FORM APPROVED Form 3160-3 OMB No. 1004-0137 Expires March 31, 2007 (April 2004) **OCD Artesia** UNITED STATES Lease Serial No. DEPARTMENT OF THE INTERIOR NMLC-029435A BUREAU OF LAND MANAGEMENT 6. If Indian, Allotee or Tribe Name APPLICATION FOR PERMIT TO DRILL OR REENTER 7. If Unit or CA Agreement, Name and No DRILL REENTER la. Type of work: 8. Lease Name and Well No. (39 330) ✓ Oil Well Gas Well Single Zone Multiple Zone RAVEN FEDERAL #20H lb. Type of Well: 9. API Well No. Name of Operator APACHE CORPORATION 30-015-3b. Phone No. (include area code) 3a. Address 303 VETERANS AIRPARK LN #3000 10. Field and Pool, or Exploratory MIDLAND, TX 79705 432-818-1167 CEDAR LAKE; GLORIETA-YESO 11. Sec., T. R. M. or Blk. and Survey or Area Location of Well (Report location clearly and in accordance with any State requirements.*) 420' FSL & 180' FEL At surface SEC: 7 T17S R31E At proposed prod. zone 420 'FSL & 330' FWL 12. County or Parish 13. State 14. Distance in miles and direction from nearest town or post office* **EDDY** NM West of Maliamar, NM 15. Distance from proposed* 17. Spacing Unit dedicated to this well 16. No. of acres in lease location to nearest property or lease line, ft. (Also

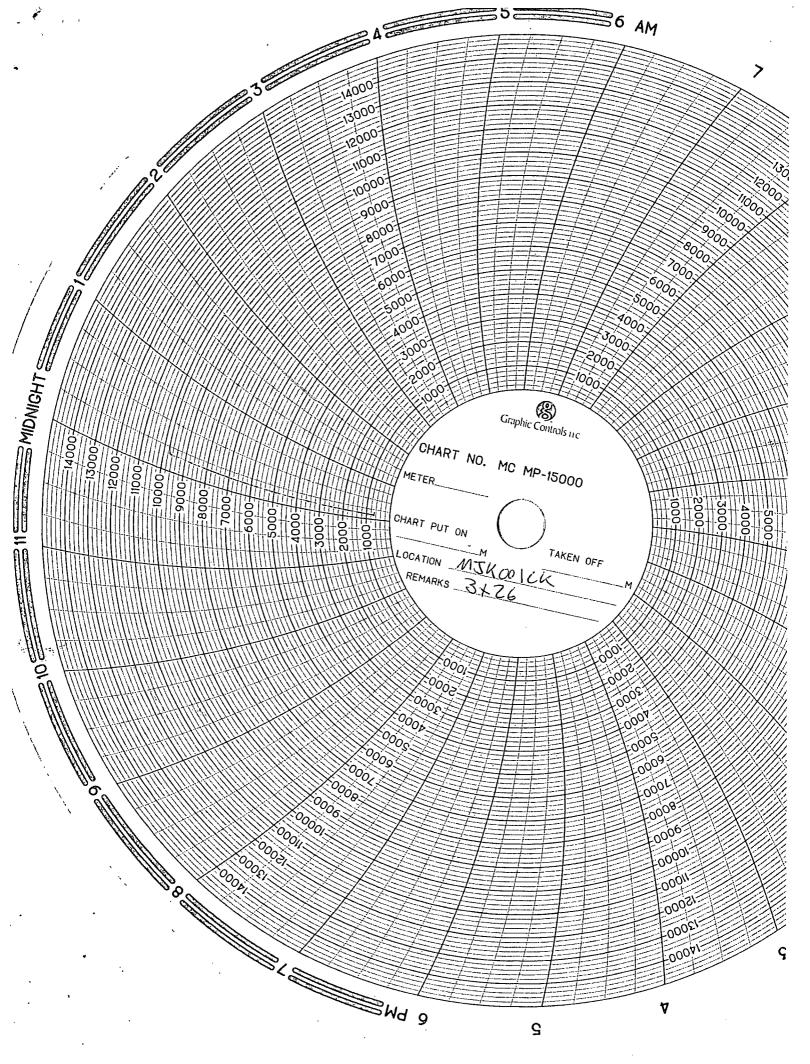
- 2. Variance approved to use flex line from BOP to choke manifold. Check condition of flexible line from BOP to choke manifold, replace if exterior is damaged or if line fails test. Line to be as straight as possible with no hard bends and is to be anchored according to Manufacturer's requirements. The flexible hose can be exchanged with a hose of equal size and equal or greater pressure rating. Anchor requirements, specification sheet and hydrostatic pressure test certification matching the hose in service, to be onsite for review. If the BLM inspector questions the straightness of the hose, a BLM engineer will be contacted and will review in the field or via picture supplied by inspector to determine if changes are required (operator shall expect delays if this occurs).
